UNITED STATES PATENT AND TRADEMARK OFFICE

Office Action Summary	Application No. 10/541,491	Applicant(s) BOWMAN, KEN	
	Examiner CHRISTINE T. CAJILIG	Art Unit 3633

DETAILED ACTION

Hendrickson et al. '877

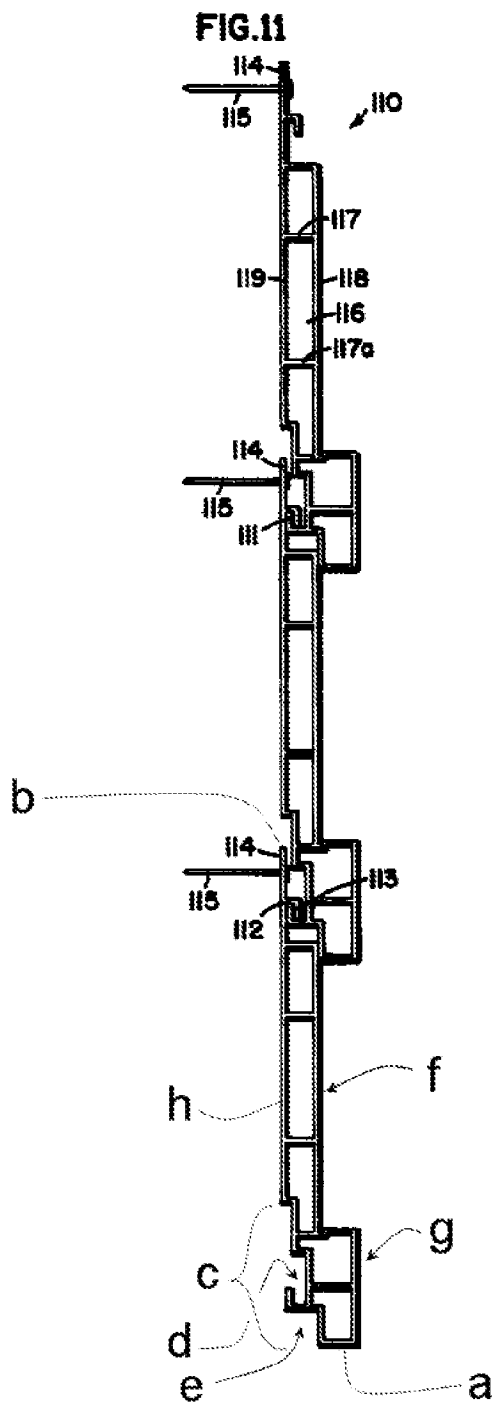
Regarding claim 1, Hendrickson et al. in Figure 11 discloses a panel having front (a) and rear (b) edges and first (h) and second side edges and adapted to interfit and interlock with similar panels when installed, comprising: a nailing flange (114) along the rear edge of the panel; at least one decorative element (118) between the nailing flange and the front edge of the panel; a longitudinal protrusion (113) extending upwardly and forwardly between the nailing flange and the at least one decorative element; an indented region (c) on the underside (119) of the panel along its front edge; a longitudinal cavity (d) in the indented region adapted to interfit and interlock with the longitudinal protrusion of an identical panel in front of it; and an additional cavity (e) on

the underside of the panel between the front edge of the panel and the longitudinal cavity of the panel, wherein, when the longitudinal cavity is interfitted and interlocked with the longitudinal protrusion of an identical second panel in front of it, the panel is latched from moving further backwards away from the second panel and the front edge of the panel is also latched against upward movement, and wherein, when the longitudinal cavity is interfitted and interlocked with the longitudinal protrusion of the second panel, the indented region of the panel, when viewed from the side of the panel, encompasses both the longitudinal protrusion and the nailing flange of the second panel.

Regarding claim 2, Hendrickson et al. further discloses at least one transverse structural support (117, 117a) running between the front and rear edges of the panel between the first and second side edges of the panel.

Regarding claim 8, Hendrickson et al. further discloses that the longitudinal cavity (d) extends substantially continuously from the first side edge to the second side edge of the panel.

Regarding claim 9, Hendrickson et al. further discloses that the longitudinal protrusion (113) extends substantially continuously from the first side edge to the second side edge of the panel.

Regarding claim 22, Hendrickson et al. further discloses that the at least one decorative element is a plurality of decorative elements (f, g).

Regarding claim 24, Hendrickson et al. further discloses that the plurality of decorative elements is arranged in a plurality of rows (f, g).
